## C-2-2 Corroborative calculations of tritium concentrations in seawater simulated in the *radiological impact assessment* using ROMS

IAEA Regulatory Review Mission on ALPS Treated Water Handling  
23 March 2022

# Methods (1)

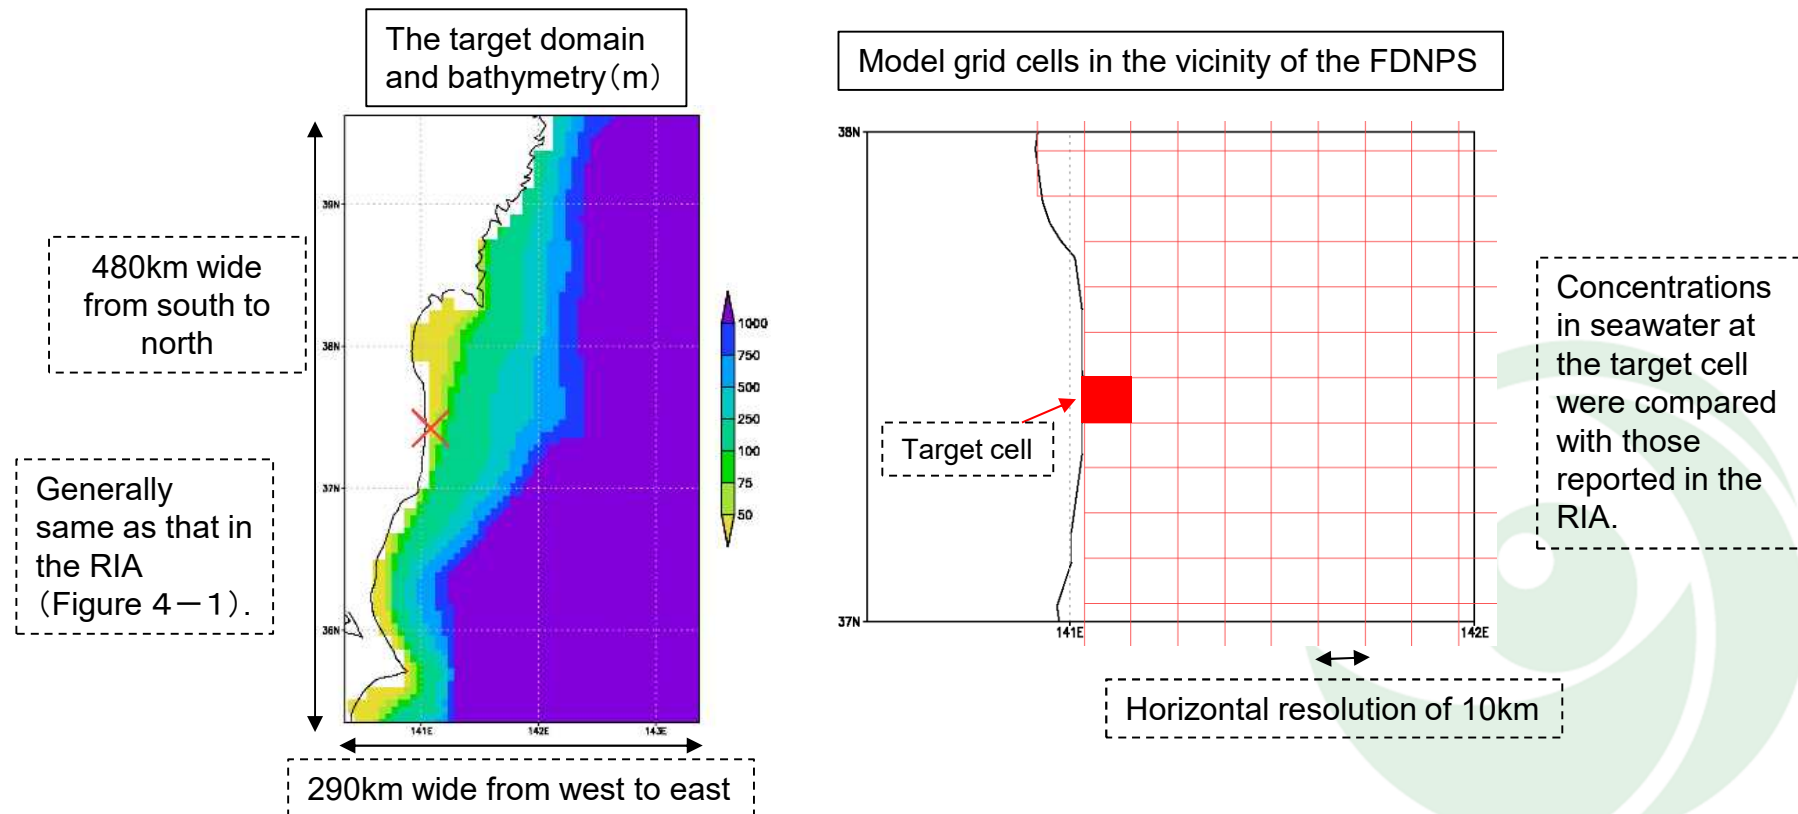
- Dispersion simulations like the RIA were conducted applying ROMS to the generally same domain with horizontal resolution not of 200m but of 10km, because the concentrations in seawater used for assessment in the RIA were those averaged over an area of 10km square.

### Time series of tritium concentrations in seawater (Bq/L)

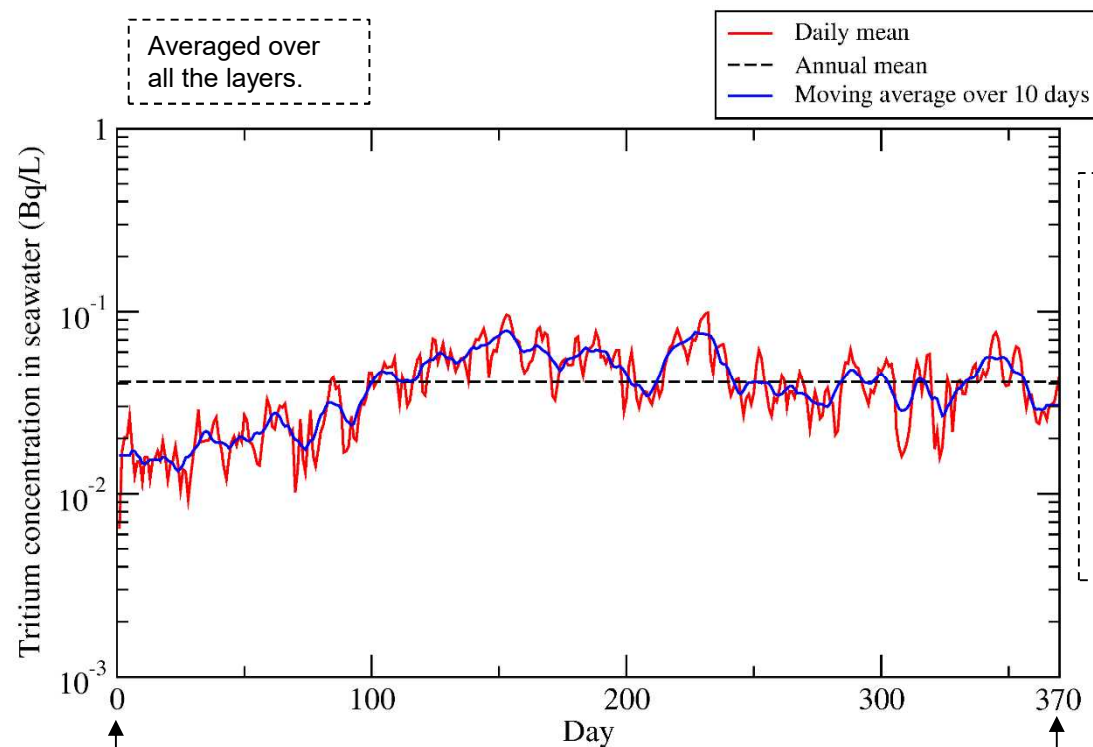
- A monotonous increase was found only in the first few days.
- It is not clear whether the cause of the gentle ascending trend in the first 100 days was accumulation or seasonality.
- After that, there was no ascending trend.
- If the year of 2019 is not an anomaly year, it is reasonable to judge that the model results for a single year of 2019 represent a typical state for whole of the duration of discharge.

The maximum value of hourly averaged tritium concentrations in seawater (Bq/L) at the lateral boundaries of the target domain

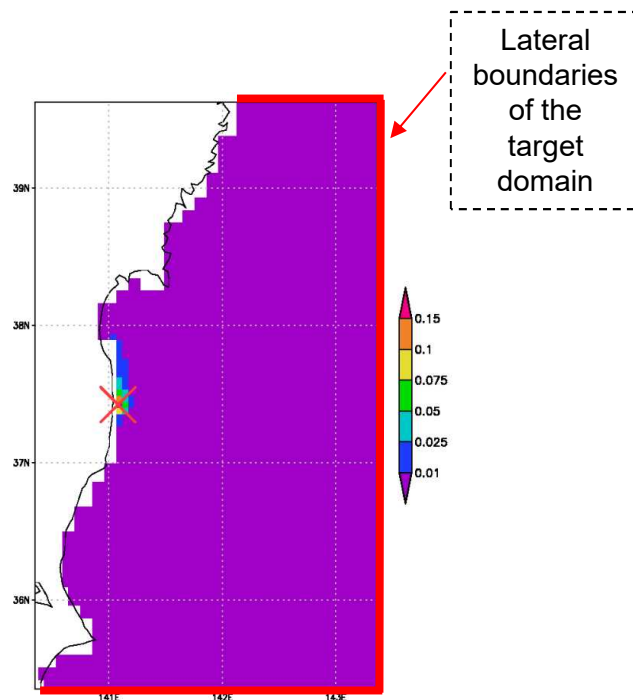
- North side:  $3.4E-4$
- East side:  $1.0E-3$
- South side:  $1.8E-3$
